Re: Agnico Response to CIRNAC Inspection Report June 20, 2022

Agnico Eagle Mines (**Agnico**) is providing this letter in response to the comments received from CIRNAC on September 6, 2022, regarding Agnico's response to the CIRNAC Inspection Report (June 20, 2022) under the Type A Water License (2AM-DOH1335).

**Photo 1 Doris Flow Meter**

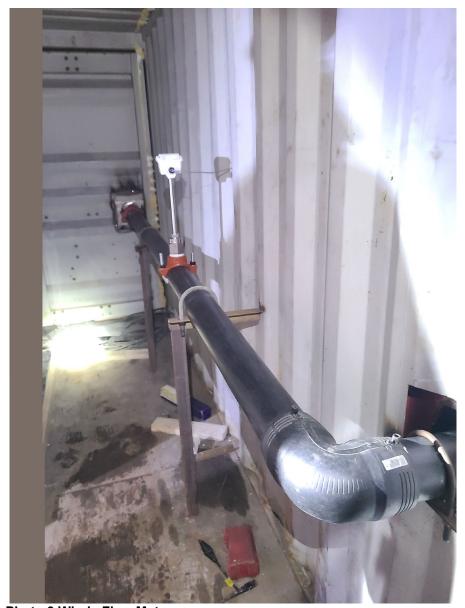
The inspector is requesting the licensee provide reasoning why it will take more than 6 months to install flow meters and is reminded that it is a requirement of the licence to install and maintain a flow meter.

Flow meters have been installed at both the Doris (Photo 1 and 2) and Windy (Photo 3) pumphouses.
